IMPORTANT PARTS-SERVICE COMMUNICATION

NO: GF-157

SUBJECT: White-Rodgers Two-Stage Gas Valves (Amana Part #'s C6476906 and C6476909)

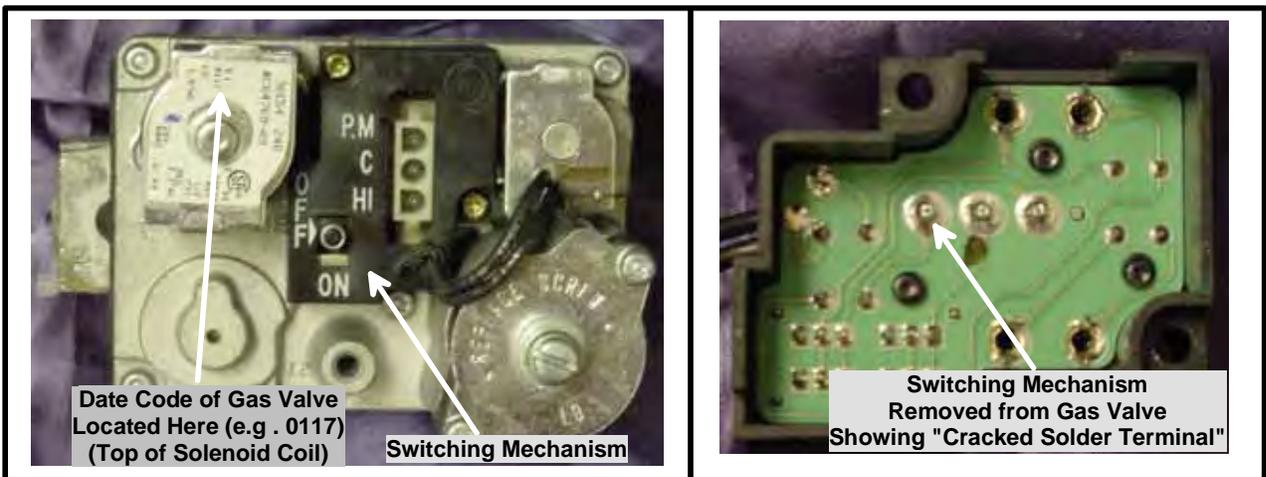
Our investigation has determined this complaint to be due to a cracked or loose connector terminal on the PC Board located inside the gas valve. This problem was found to be created when too much force is applied to the wiring harness connector as it is being connected to the gas valve causing the connector terminals to break the solder on the backside of the PC board. This issue affects only two-stage gas valves manufactured with serial *date codes prior to 0215*. Refer to the following figure for locating the date code on the gas valve.

To help in troubleshooting this type of problem, it will be necessary to wiggle the connector on top the two-stage gas valve with the furnace in a call for heat. If the furnace locks out giving a steady on LED fault code, then it more than likely points to a cracked or loose connector terminal, which will require replacement of the two-stage gas valve. For further verification of this problem, turn "OFF" the thermostat to the furnace and disconnect all power to the furnace. Using a pocket screwdriver, carefully remove the switching mechanism (black section on top of two-stage gas valve with ON/OFF switch) by removing the two *TORX Screws* that secure it to the gas valve and inspect backside of PC board for a loose or cracked connector terminal. If any of the three-connector terminals are loose or cracked, replace the two-stage gas valve and then reapply power and check for proper unit operation. **Note:** The two screws holding the switching mechanism onto the two-stage gas valve are *TORX Screws*, and as previously mentioned, they can be removed with the use of a standard pocket screwdriver. Refer to the following figure for an example of the switching mechanism removed showing a cracked connector terminal.

To correct this condition, we have implemented procedures to prevent excessive force being applied when connecting the wiring harness to the gas valve and White-Rodgers has made improvement to the terminal board. All two-stage gas valves manufactured with a serial date code of **0215 and later** include these improvements.
